2610
9.14m LOTS
GARDEN 4 (GR)
ELEVATION 1,2 & 3
A1 PACKAGE
O.REG. 332/12

TITLE SHEET
BARLASSINA CONSTRUCTION
CITY OF CAMBRIDGE

CITY OF CAMBRIDGE
BUILDING DIVISION

THESE PLANS have been examined for compliance
with the Ontario Building Code Requirements. A
Building Permit is in Order to issue subject to any
changes noted under the condition that the building will
be constructed in accordance with the code

BASEMENT PLAN EL-1
BARLASSINA CONSTRUCTION
CITY OF CAMBRIDGE

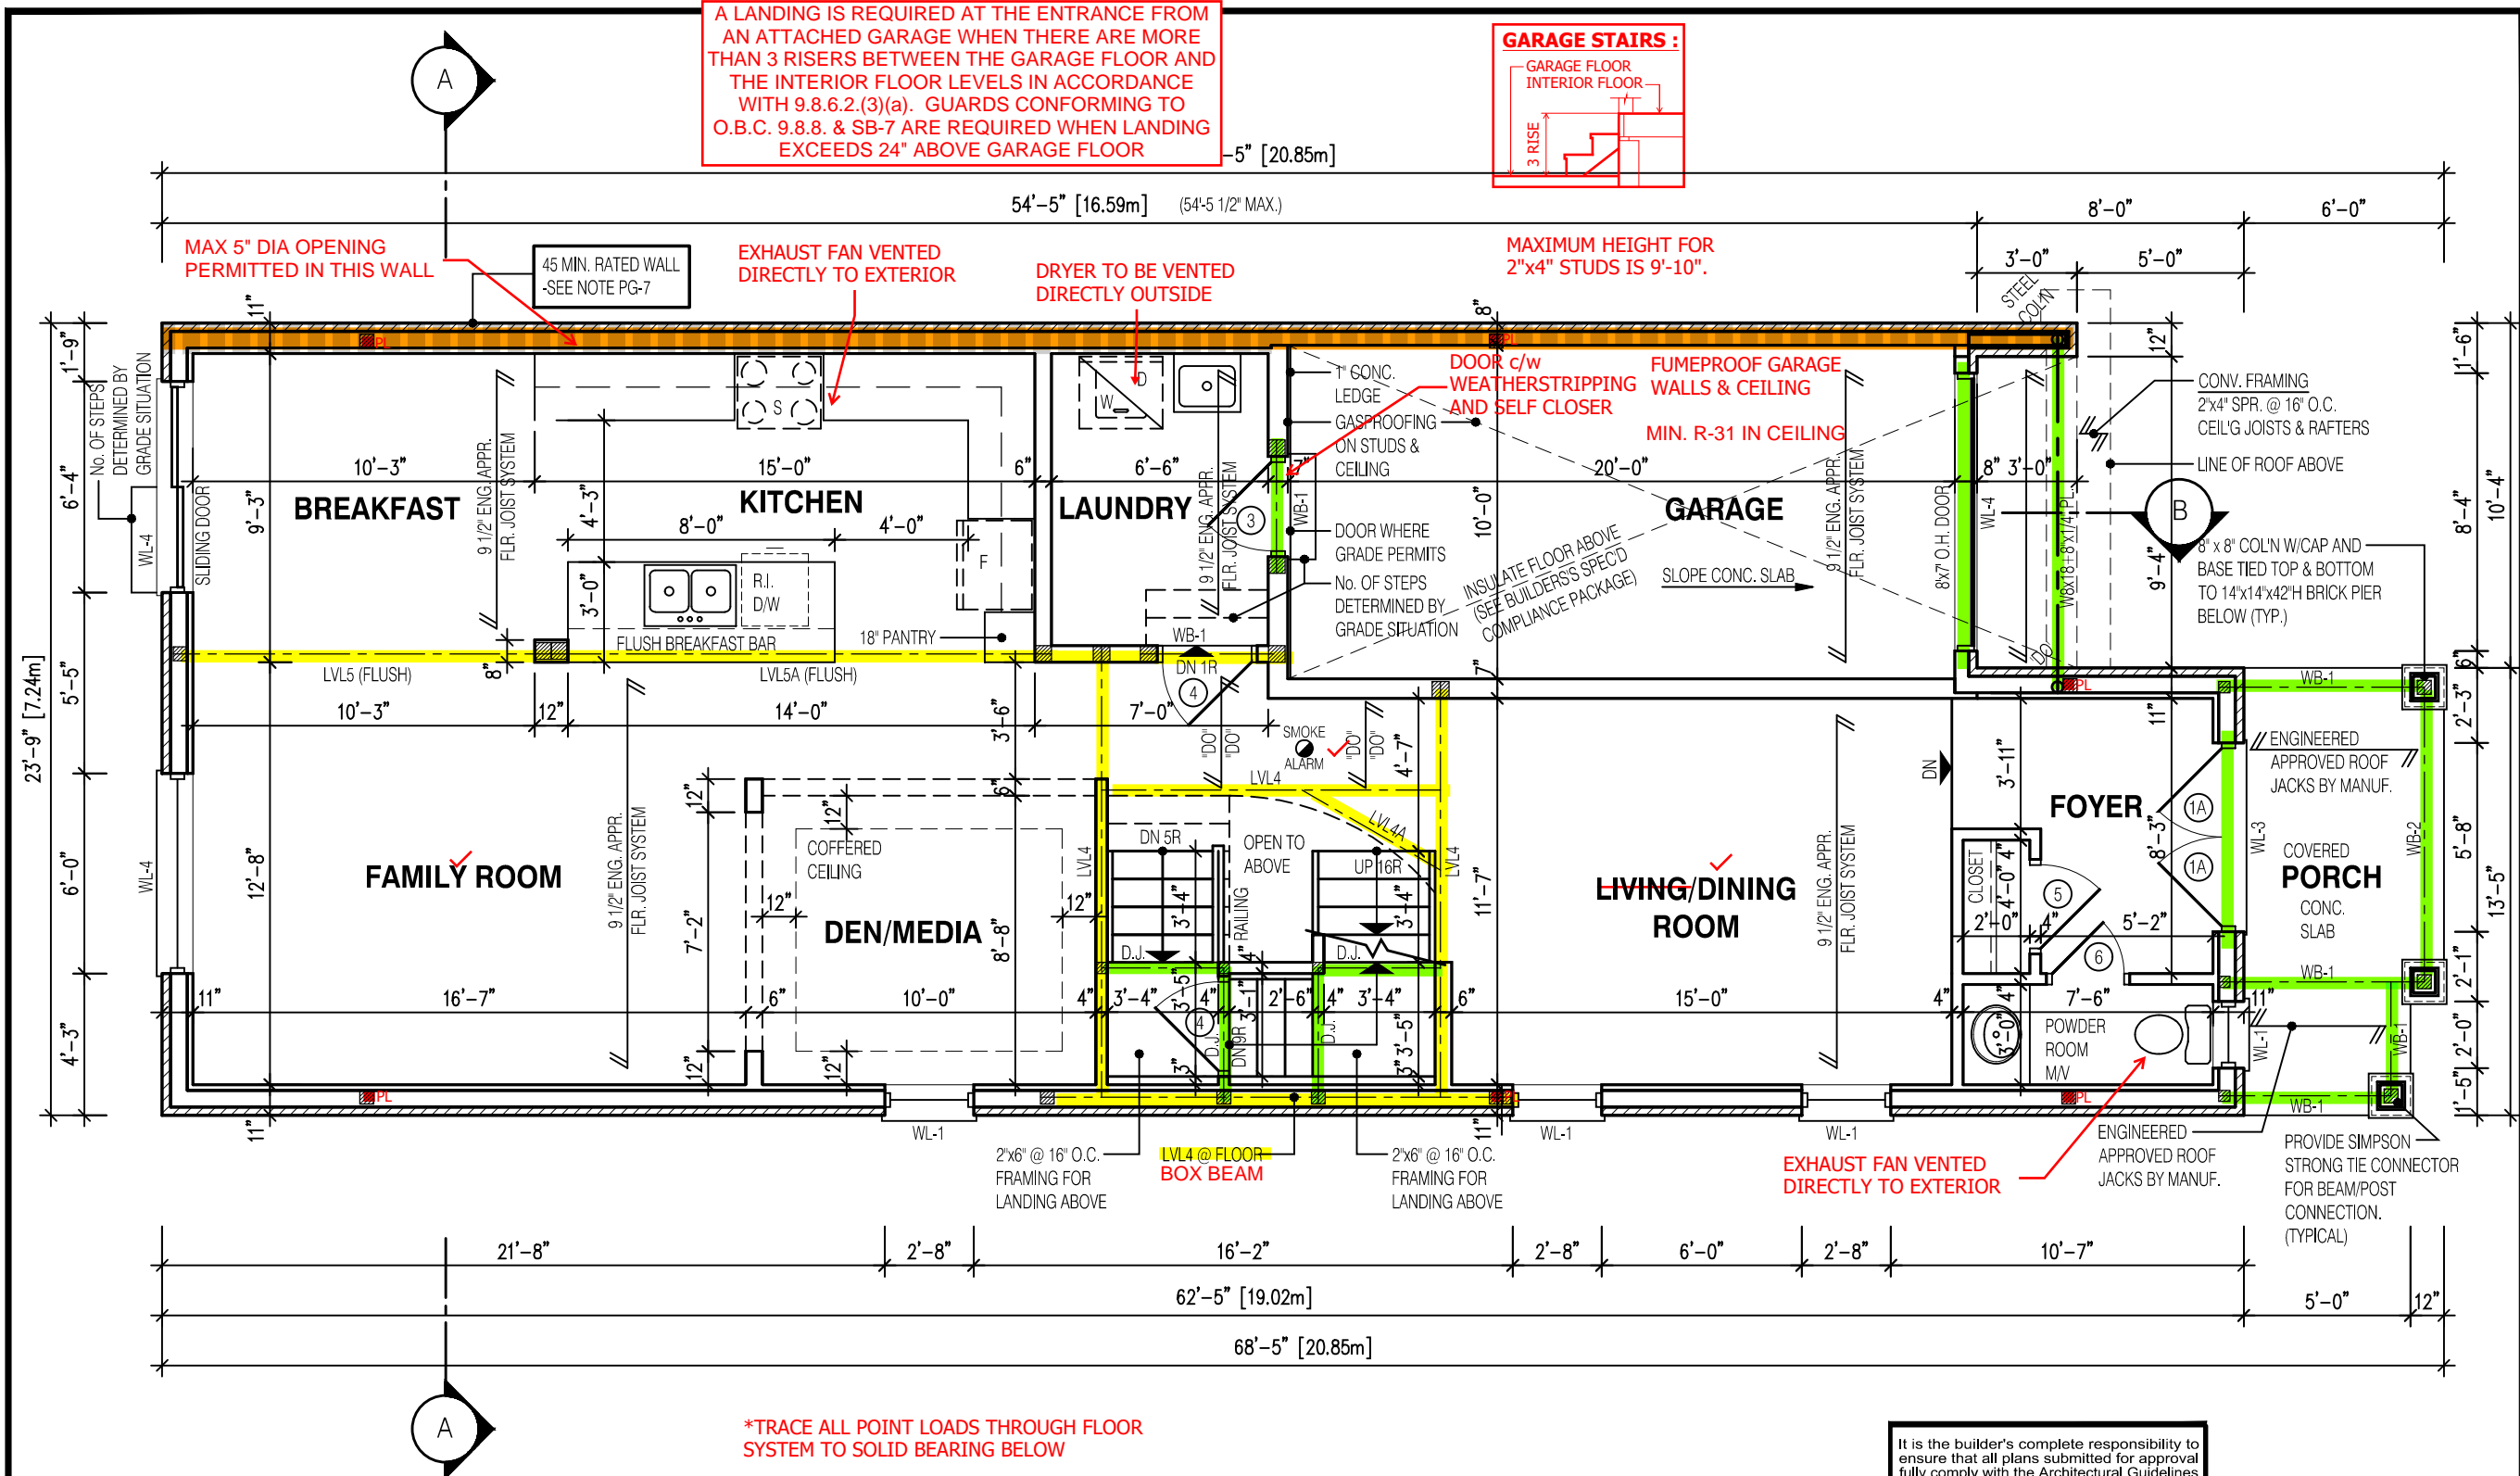
REQUIRED CONTINUOUS INSULATION
CANNOT BE INTERRUPTED BY FRAMING
MEMBERS SUCH AS STUDS

NON-LOAD BEARING WALLS NOT
PERMITTED TO BE FRAMED (TYP.)

MINIMUM CEILING HEIGHT 6'-11"
MINIMUM CEILING HEIGHT
UNDER BULKHEADS 6'-5"

3 1/2"x 3 1/2"x 1/4" STEEL BRICK ANGLE
TYPICAL UP TO MAX. 8'-1" SPAN

VERIFY WATER METER AND DWHR
UNIT LOCATION WITH INSPECTOR

SPRAY FOAM/RIGID INSULATION TO BE
PROTECTED AS PER 9.10.17.10.(1)

WATER METER TO BE INSTALLED WITHIN 2m
(6'-6") FROM THE POINT THE WATER SERVICE
PIPE MEETS THE BUILDING LINE

DECK CONDITION EL-1

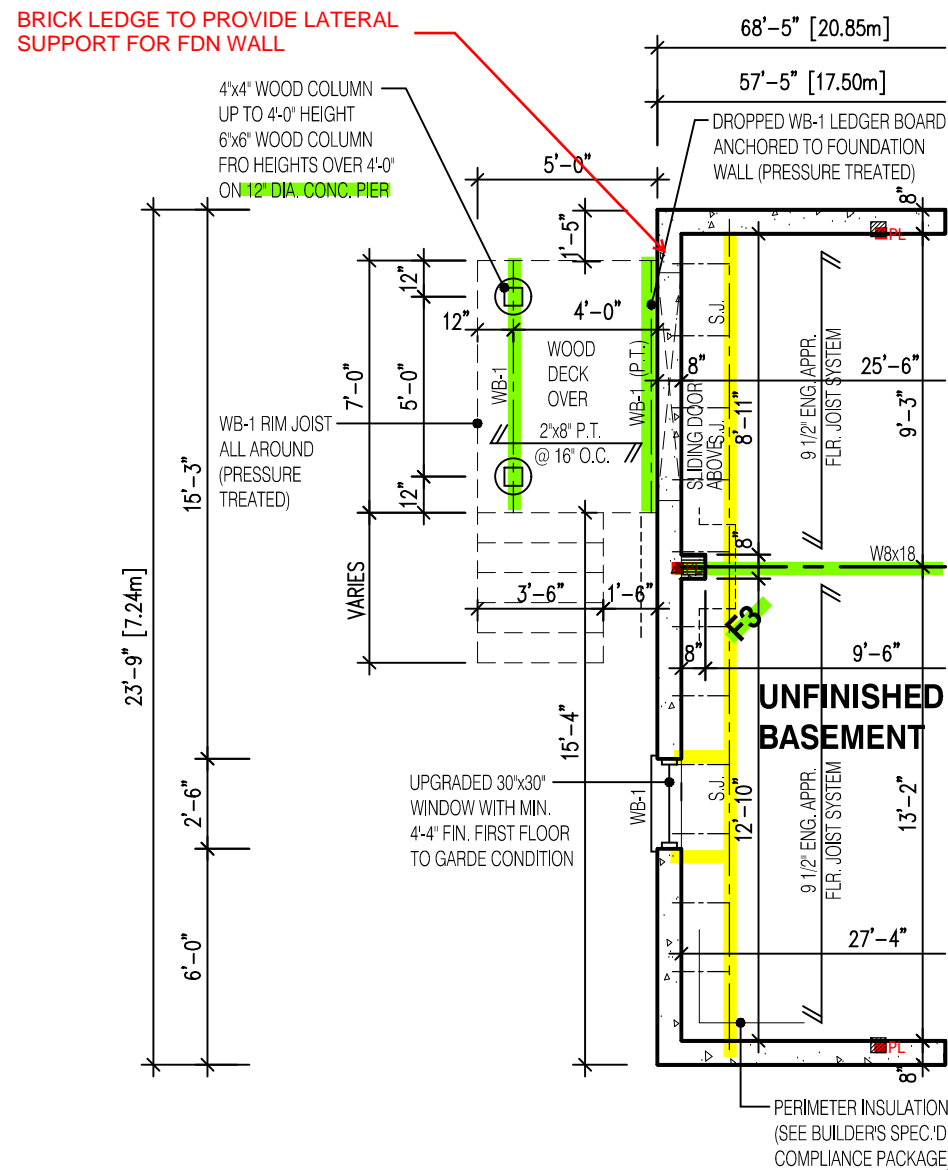
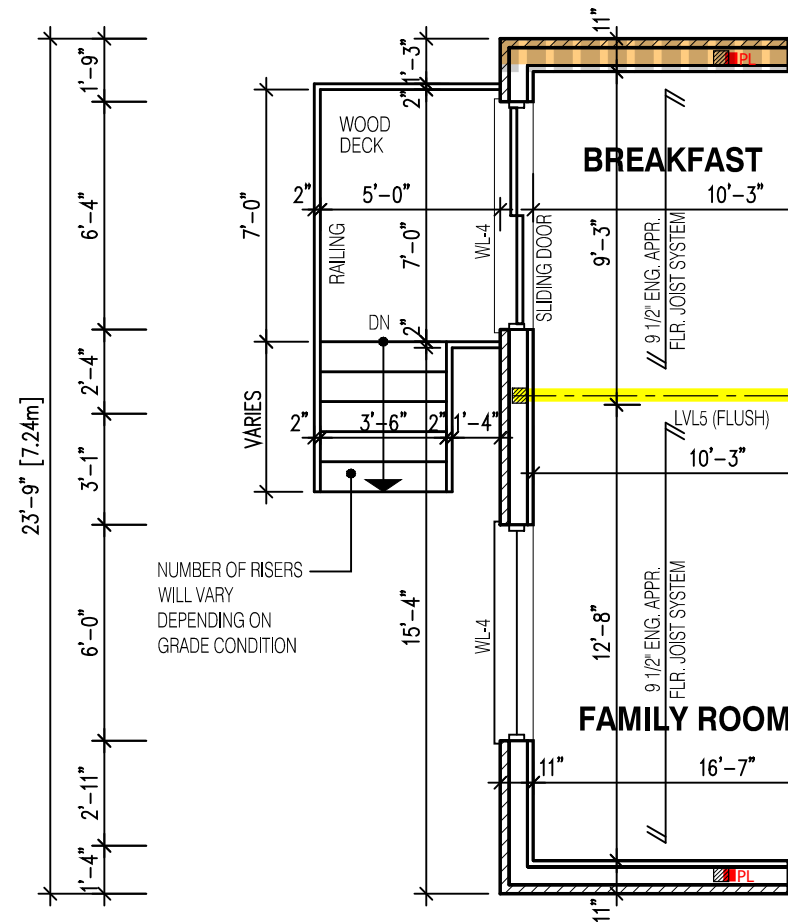
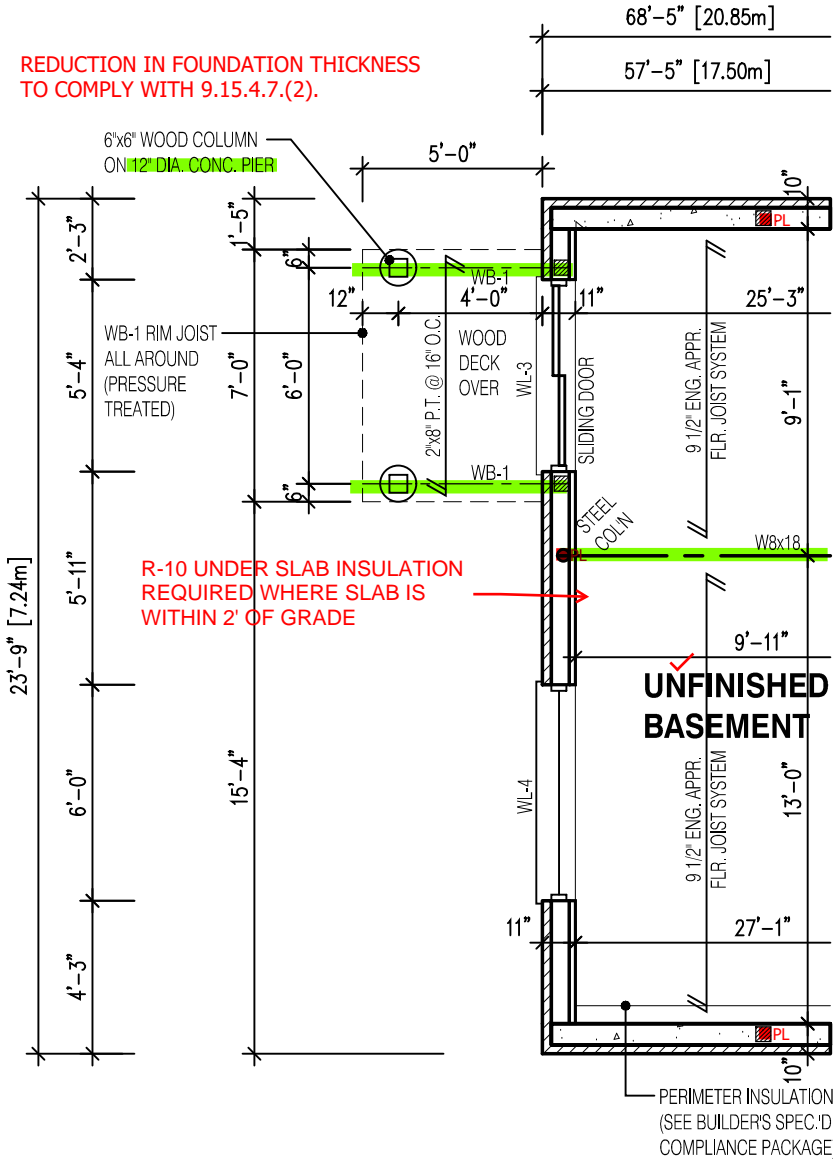
ALL GUARDS TO COMPLY WITH SB-7 OR P.ENG DESIGN.
GUARDS TO BE MIN. 36" HIGH (900mm). WHERE DECK
WALKING SURFACE TO FIN. GRADE EXCEEDS 5'-11"
(1.8m), GUARD HEIGHT TO BE 42" HIGH (1.2m)

ENSURE P.ENG STAMPED RAILING
DOCUMENTATION AND ATTACHMENT DETAILS
ARE AVAILABLE FOR REVIEW BY THE INSPECTOR

GUARDS CONFORMING TO O.B.C. 9.8.8.
& SB-7 ARE REQUIRED FOR PORCHES
EXCEEDING 24" ABOVE GRADE.

LEFT SIDE ELEVATION 1

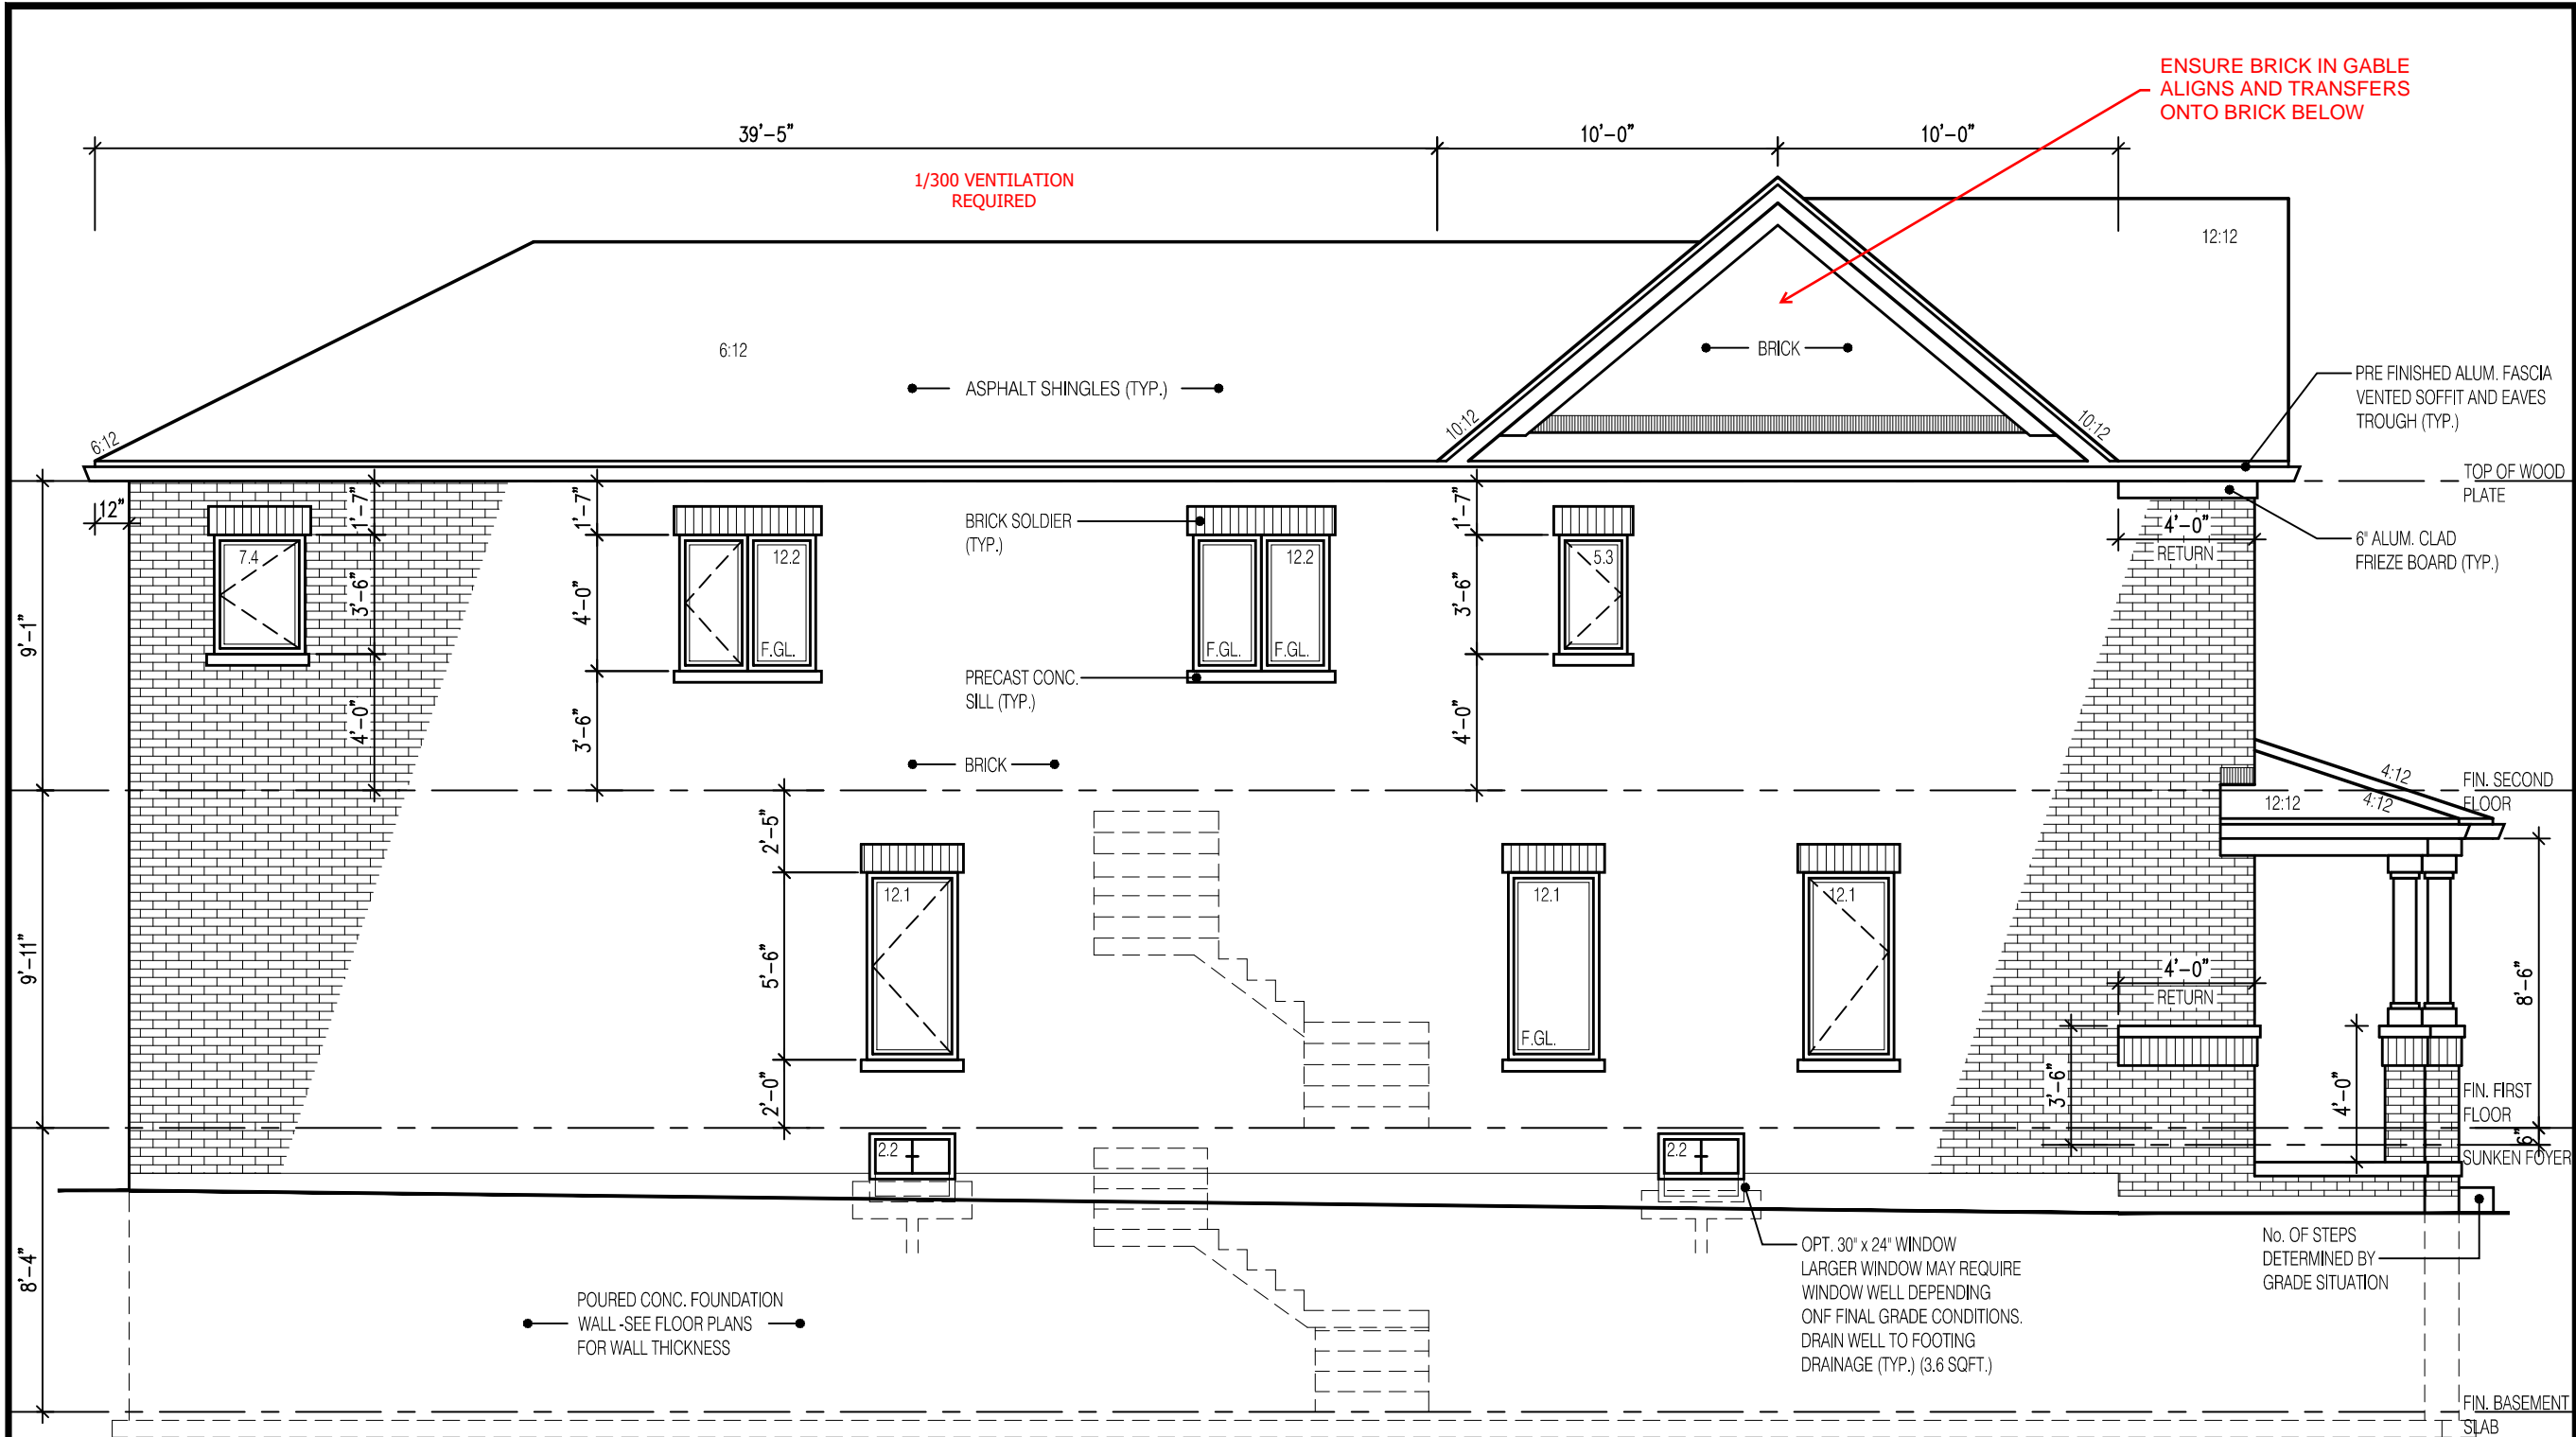
WALL AREA	1330	⌀
ALLOWABLE WINDOW AREA @ 7.0% (1.2m SIDEYARD)	93.1	⌀
ACTUAL GLAZED AREA	77.8	⌀
WITH OPTIONAL 30"x24" BASEMENT WINDOWS		
ACTUAL GLASS AREA	80.6	⌀ ✓
